ECE/TRANS/WP.29/GRE/2008/34 11 July 2008

### COLLECTIVE AMENDMENTS

Proposal for draft collective amendments to Regulations Nos. 48 and 98

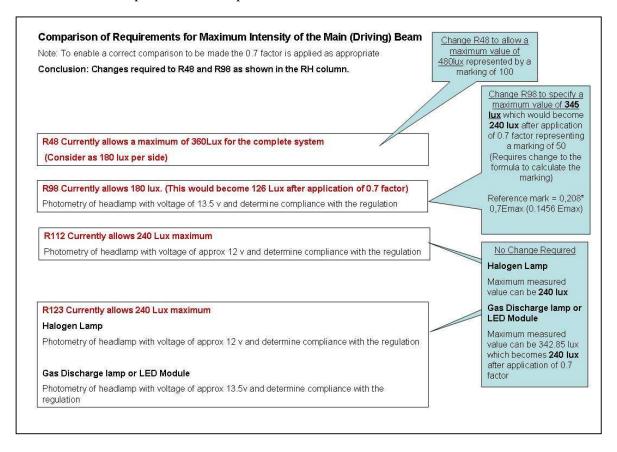
Currently there is an inconsistency between Regulation No. 48 and the headlamp Regulations relating to the provision limiting the total maximum intensity of all main beams that may be operated simultaneously on the vehicle.

This proposal is intended to increase the maximum value in Regulations Nos. 48 and 98 to 300,000 candela (relating to an aggregate reference mark of 100) to align with the existing provisions of Regulations Nos. 112 and 123.

Regulation No. 48 currently limits the total intensity of the main beam to 225,000 cd (relating to an aggregate reference mark of 75). This was introduced at a time when installation of the class

"A" headlamp was permitted on  $M_1$  and  $N_1$  vehicles. Due to the low photometric performance of the passing beam of the class "A" headlamp it was necessary to limit the driving beam intensity to avoid an unacceptable contrast when switching from driving to passing beam. Following the deletion of the class "A" headlamp and improvements in passing beam performance of modern headlamps, it is now appropriate to raise the limit of the maximum driving beam intensity and so remove a restriction to the optimisation of headlamp system performance.
